**MONTGOMERY COUNTY HISTORIC PRESERVATION COMMISSION**  
**STAFF REPORT**

<b>Address:</b>	16101 Oak Hill Road., Silver Spring	<b>Meeting Date:</b>	11/13/2019
<b>Resource:</b>	Master Plan Site 15/52 <b>Edgewood II</b>	<b>Report Date:</b>	11/6/2019
<b>Applicant:</b>	Steven Gudelsky	<b>Public Notice:</b>	10/30/2019
<b>Case Number:</b>	15/52-19A	<b>Tax Credit:</b>	n/a
<b>Review:</b>	HAWP	<b>Staff:</b>	Dan Bruechert
<b>Proposal:</b>	Door Replacement and other Alterations

Staff recommends that the HPC **approve with one (1) conditions** the HAWP application:

1. Because the proposed foundation work is to match the historic appearance, Staff should be directed to field-verify that the new foundation match the appearance and materials of the historic.

North side, Infill between existing piers with stone, recess 2"

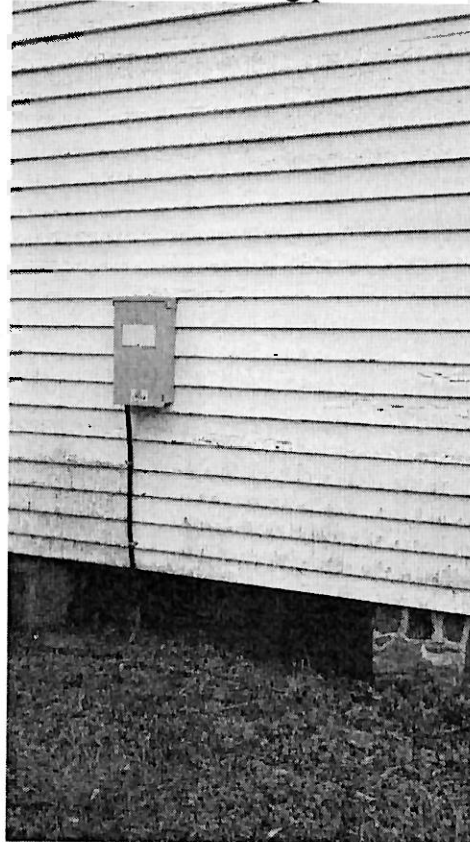
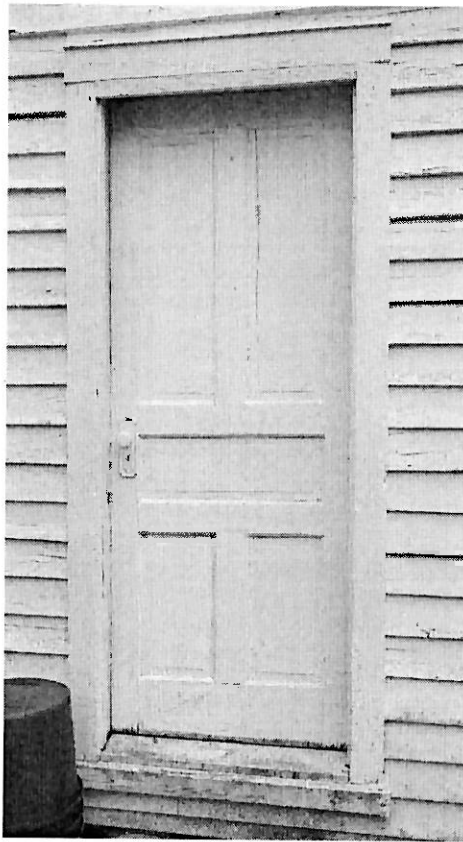
The other alteration proposed for the north elevation involves the repair of the foundation supporting the original massing of the house. This foundation is constructed on stone piers that have begun to degrade and need to be repaired and/or replaced. The applicant proposes constructing a new foundation faced in stone to match the appearance of the historic continuous foundation found in other areas of the house. Staff finds that this repair is necessary to support the floors and to keep the house from settling further. Because of the rustic, vernacular construction of the house and foundation, a specification sheet for this product cannot be provided by the applicant. While Staff recommends approval for this work under 24A-8(b)(2) and (4), Staff recommends the HPC include a condition for approval of the foundation repairs that the foundation work be field verified by Staff to ensure that the new stone veneer matches the materials, texture, and appearance of the historic stone foundation.

1. Because the proposed foundation work is to match the historic appearance, Staff should be directed to field-verify that the new foundation matches the appearance and materials of the historic foundation;

1 WEST ELEVATION  
SCALE 1/4" = 1'-0"

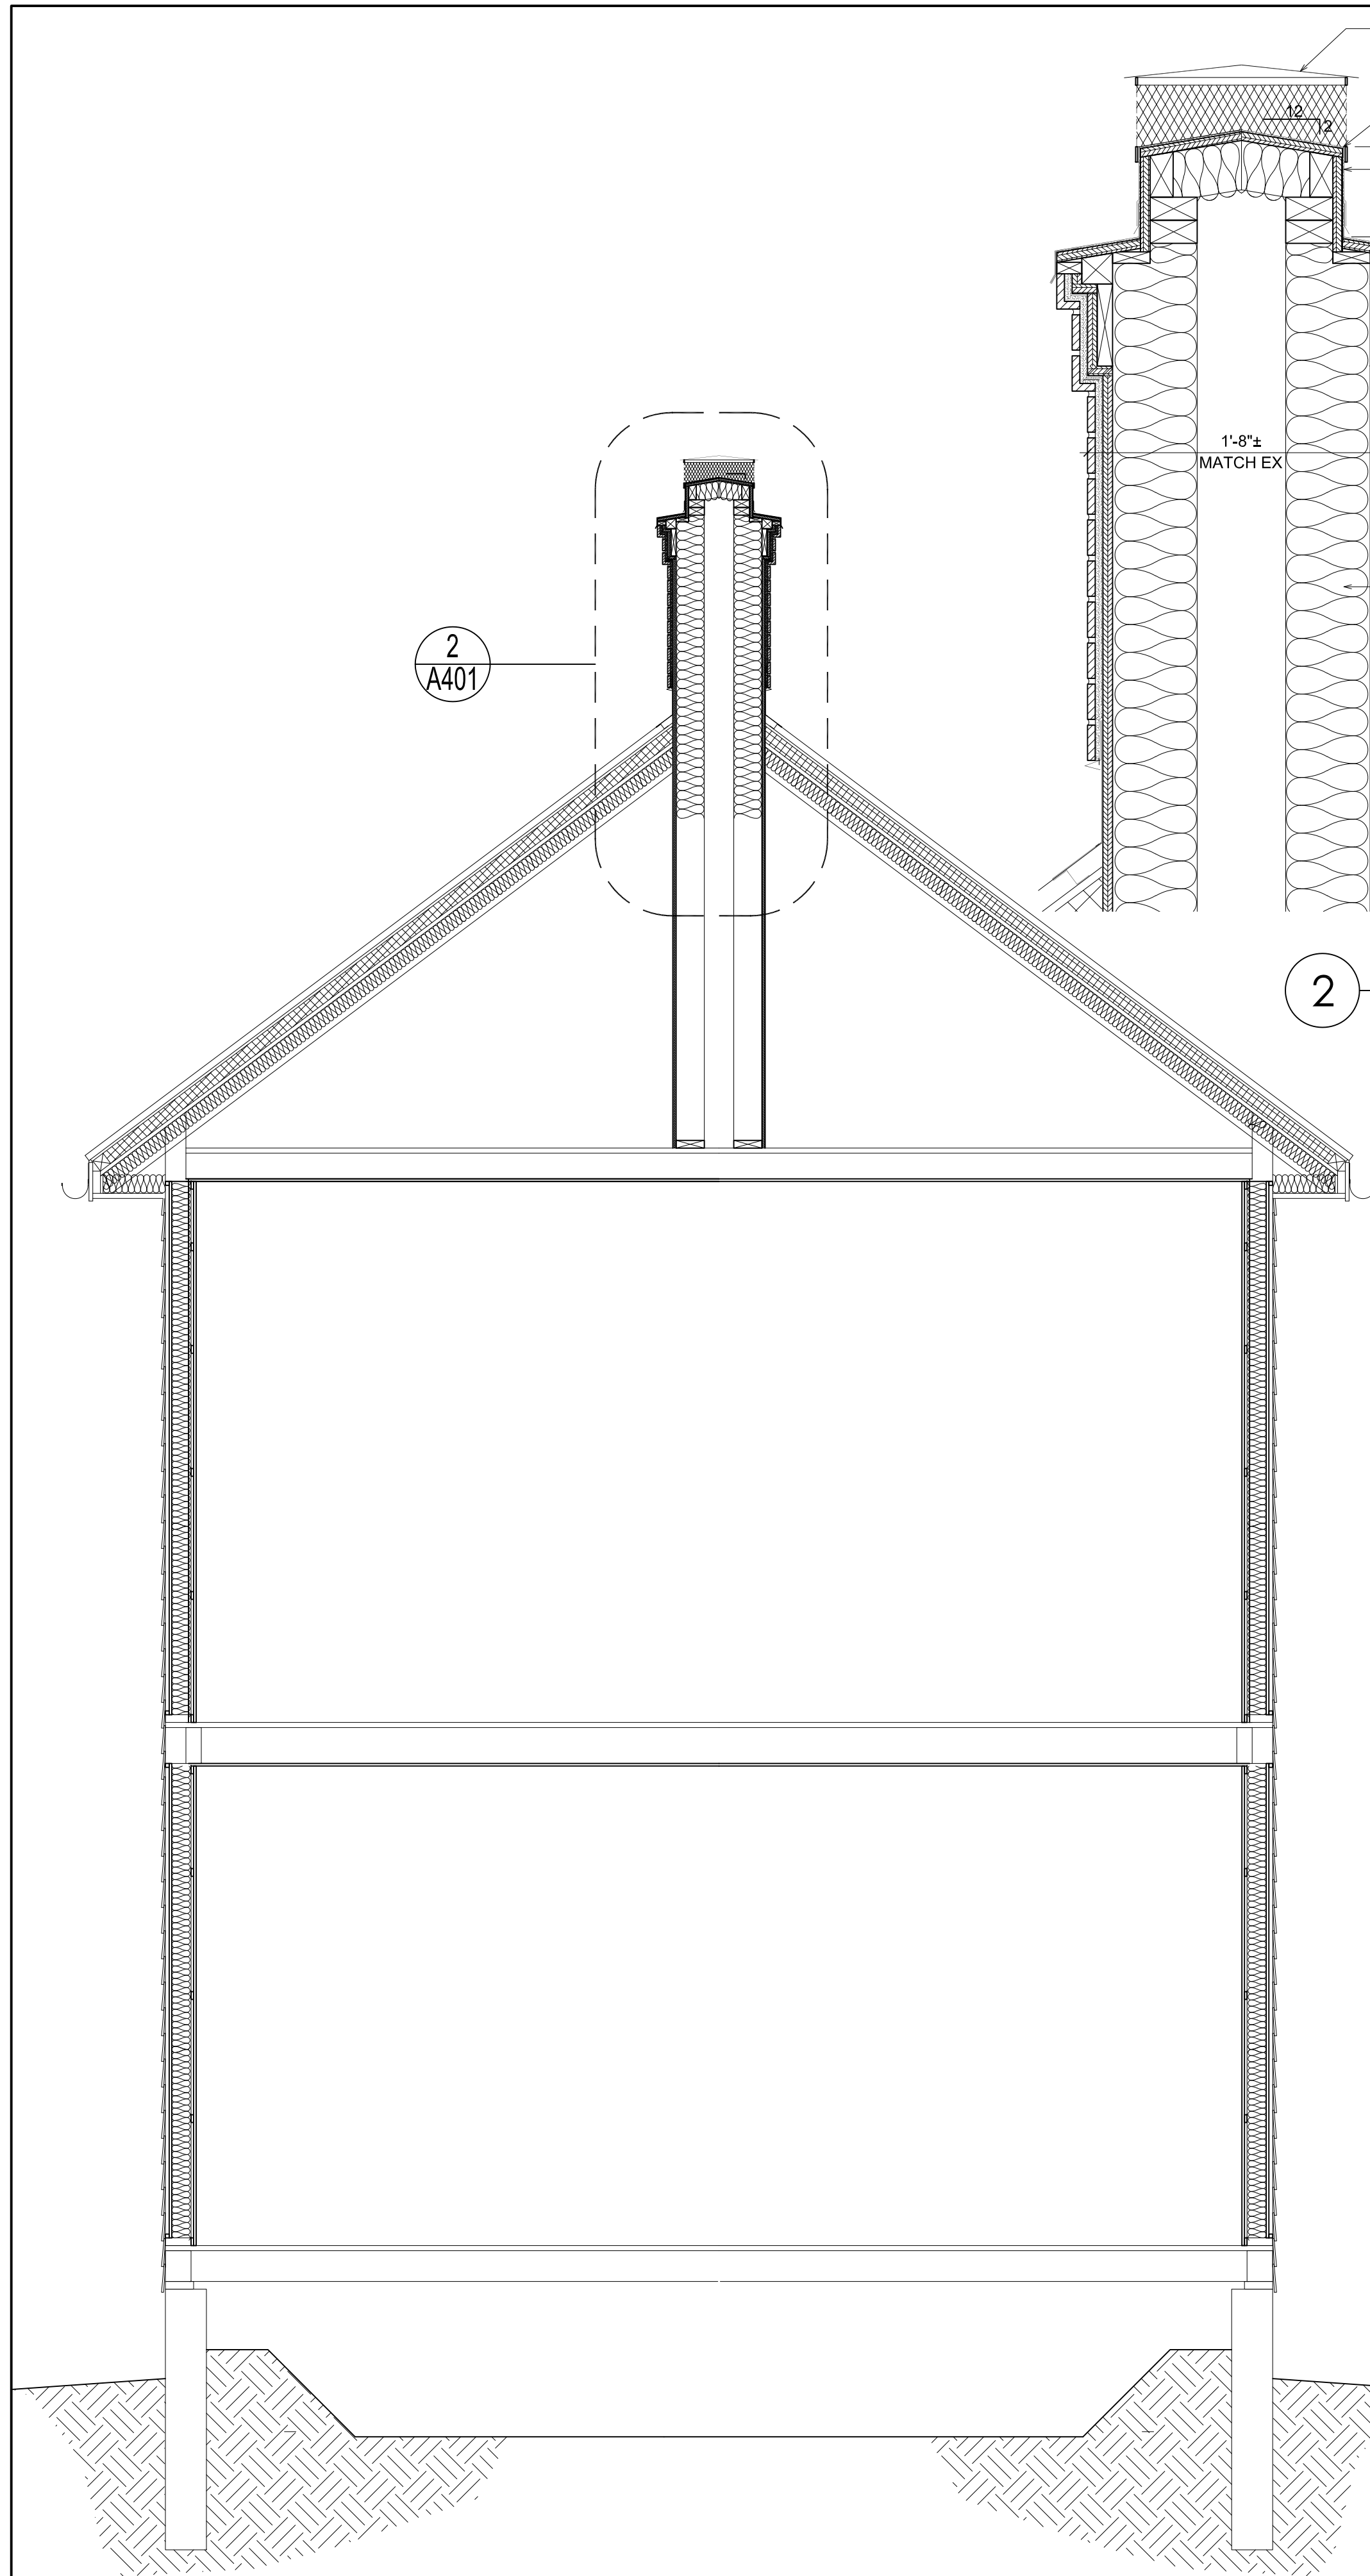
The view from the west shows mostly the c.1904 addition that has been heavily modified. Originally, the

addition was only two bays wide, with a porch that wrapped around the north. The second floor was later modified to enclose what was likely a sleeping porch. This change is seen both in changes to the foundation and to the interior framing of the house (observed by Staff on site). For reasons Staff cannot figure out, a second door was installed in the central bay of the house. The applicant proposes removing the central door, which was a later modification, and installing a window and repairing the clapboard siding below in its place and restoring the left door. The applicant also proposes installing a simply detailed wood railing around the left and right ends of the porch.

The historic photos included in the application showing the “View from West, Oak Hill Rd.” and “View from South West” show the west porch enclosed with two different configurations. The earlier photo shows a simple vertical picket design, while the later photo shows a more decorative, Chippendale railing design. As there is a historical precedent for a railing in this porch, Staff finds that either design would be acceptable, but supports approval of the installation of the simple wood railing proposed under 24A-8(b)(1). Additionally, Staff supports removing the central door and converting that opening into a window with siding repairs below. The proposed window will match the materials and appearance of the historic wood windows and Staff finds this work to be largely restorative and recommends approval under 24A-8(b)(1).

1 SOUTH ELEVATION  
SCALE 1/4" = 1'-0"

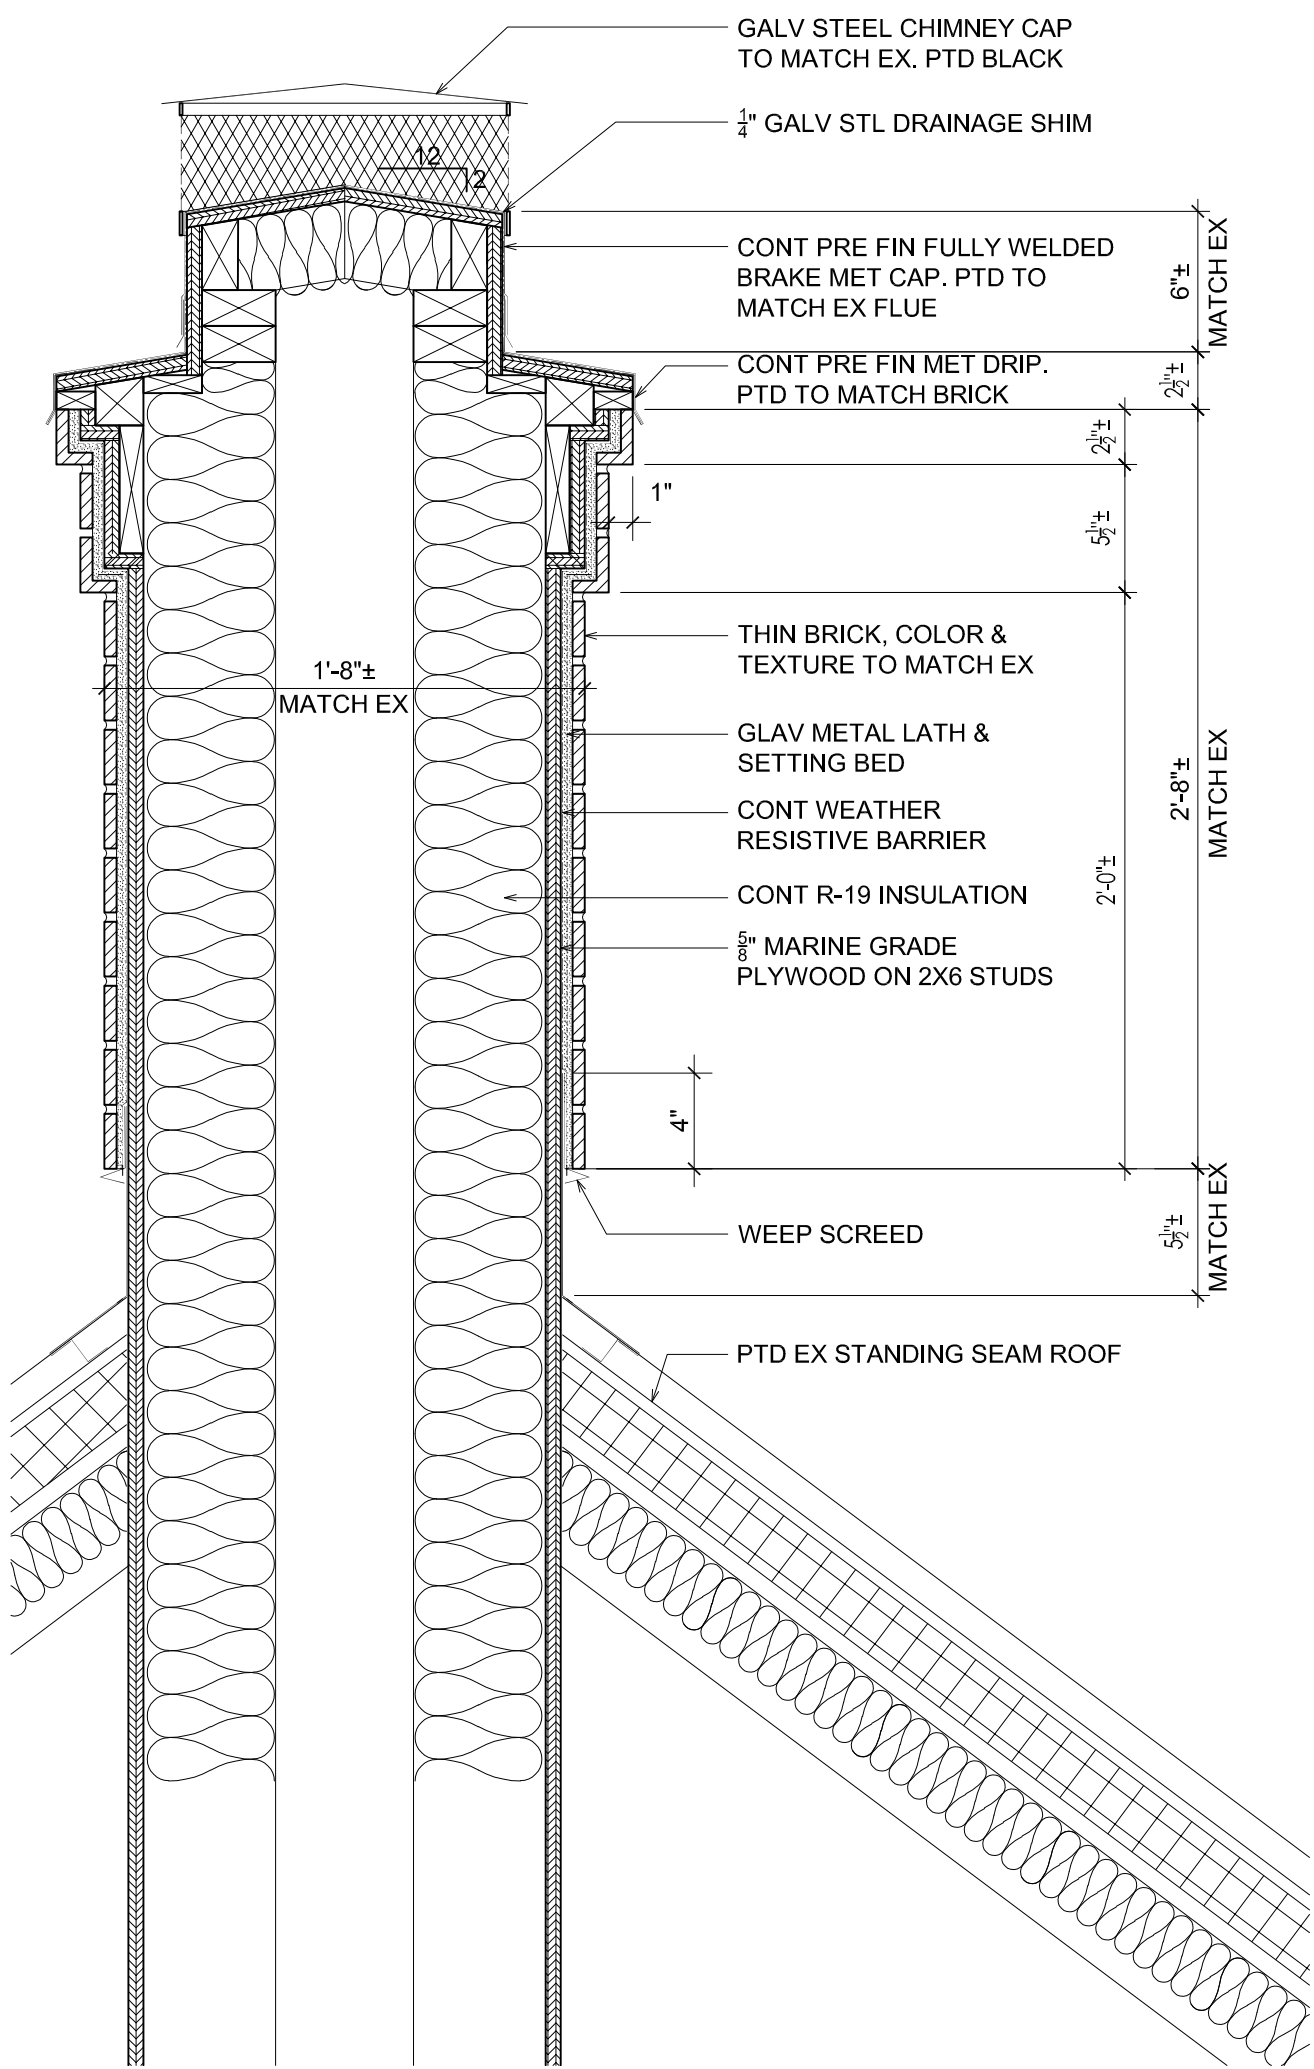
The south elevation is the historic front of the house. Most of the work identified in the work notes is restoration, however, there are few details of work that require a HAWP. The applicant proposes removing and replacing the front door. At a site visit Staff determined that the extant door is not historic, due to the fact that there are hinge marks on the inside of the door jamb indicating that the door's swing has been altered, and the door jamb has been shrunk with one-by lumber pieces installed. In place of the existing door, the applicant proposes to remove the one-bys, change the door swing, and install a new wood door to fully fill the historic jamb. The new wood door will match the four-panel configuration of the existing door, which Staff finds to be period appropriate and compatible with the house architecture, per 24A-8(b)(1).

The other change visible from the south elevation is the removal and reconstruction of the central chimney. The central chimney is one of five on the historic house and is constructed out of brick. The applicant will remove this chimney to the basement and construct a CMU chimney faced with historic bricks on a new frame in the attic. The chimney will maintain the existing appearance but will not be functional. Staff finds this will not alter the appearance of the house and its approval is supported by 24A-8(b)(1) and Standard 2.
